PLANNING COMMISSION STAFF REPORT

Meeting Date November 15, 2022

AGENDA ITEM: Residential Apartment Project, 3090 Southlawn Drive
 a. Preliminary Plat
 b. Wetland Buffer Variance

Engineering Plan Review

EXHIBIT 3. WETLAND BUFFER PROPOSED CONDITIONS

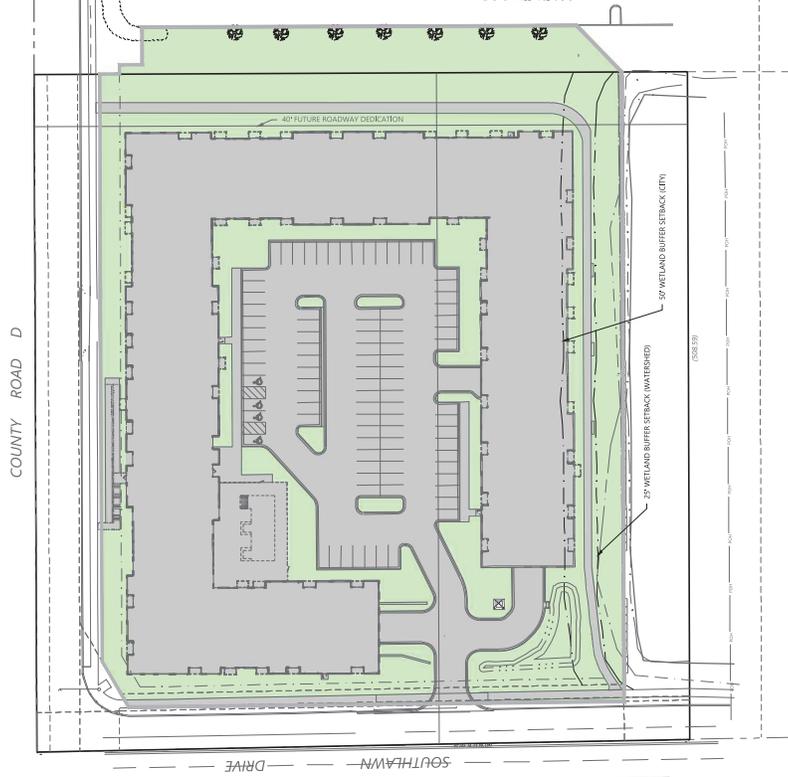
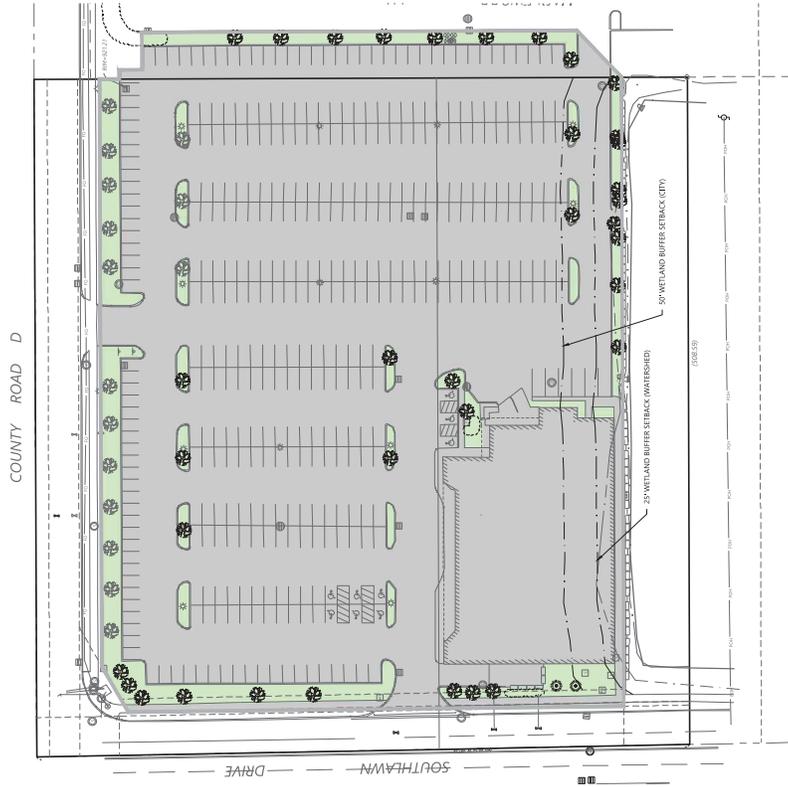
The building will be constructed with an average setback of 42.9 feet to the wetland and the sidewalk on the south side of the building will come to within 25 feet of the wetland. The applicants are proposing to plant native trees, shrubs, and seed within the 25 feet of green space between the sidewalk and the wetland.

In order to remove the existing building, sidewalk, surface parking lot, and retaining wall the applicants must grade up to the wetland, which will require a **50-foot wetland buffer variance**.

- a. Prior to issuance of a grading permit the applicant must:
 - 1) Submit a wetland buffer mitigation plan as follows:
 - a) Native Plugs: Include native plugs to be installed within the 25-foot re-established wetland buffer. Currently the landscape plan identifies a pollinator seed mix. Using plants rather than seeds hastens establishment and provides a better chance of successful establishment. The applicants should plant all plugs, or a mix of plugs and native seed mix in this area.

- b) Seed Mix:
 1. Provide information on the percentages and species of native seed mix.
 2. Provide information on the maintenance required for the planting year, and years two and three, addressing what maintenance activities will be required and what entity (developer, owner, etc.) will take on the responsibility.

- c) Wetland Buffer Signs: Identify on the wetland buffer mitigation plan the location of wetland buffer signs. The City of Maplewood supplies wetland buffer signs identifying that no building, mowing, or grading should take place within the buffer. There is a \$35 fee per sign. The applicant must install the signs at the newly established wetland buffer edge (25 feet). The signs should be placed every 100 feet at a minimum.
